Case No.     DSP-13007  
                  Royal Farms-Allentown Road

COUNTY COUNCIL OF PRINCE GEORGE'S COUNTY, MARYLAND,  
SITTING AS THE DISTRICT COUNCIL

ORDER AFFIRMING PLANNING BOARD DECISION,  
WITH CONDITIONS

1 FRONT ELEVATION  
SCALE = 1/8" = 1'-0"

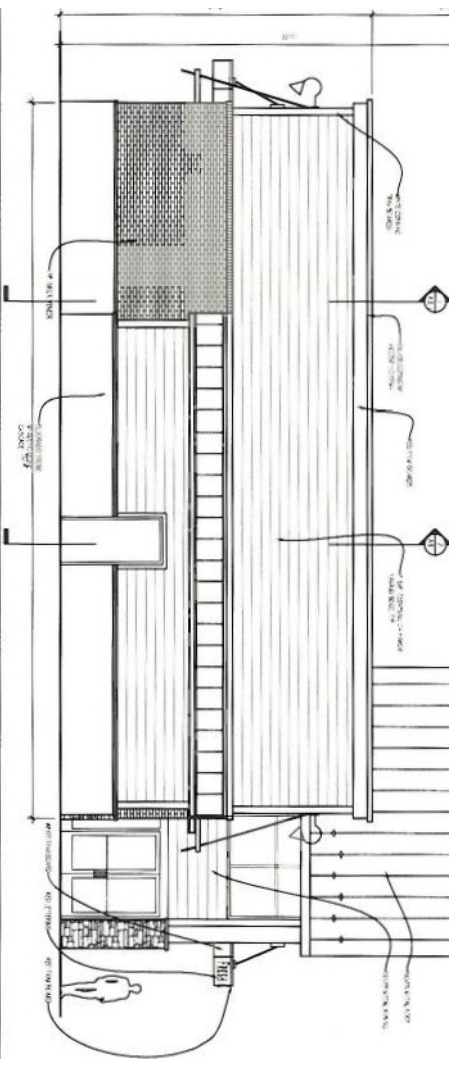
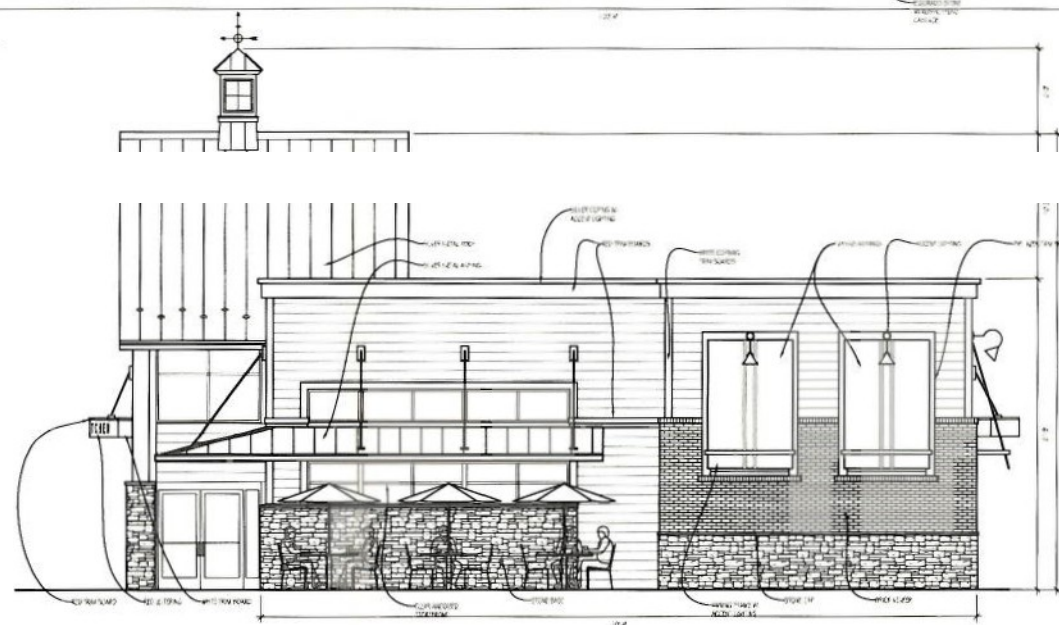
1. Prior to certificate of approval of the detailed site plan, the following revisions shall be made, or information shall be provided:
  - a. The site plan and elevations for the primary building shall be revised as shown on Exhibit A.

- e. The signage base shall be revised to incorporate brick support columns, instead of a solid wall.
  - f. All of the proposed building materials, colors, and finishes shall be labeled on the architectural elevations.

- (3) The color and appearance of the red brick on the proposed primary building, canopy support columns, walls, and features across the site shall be consistent;
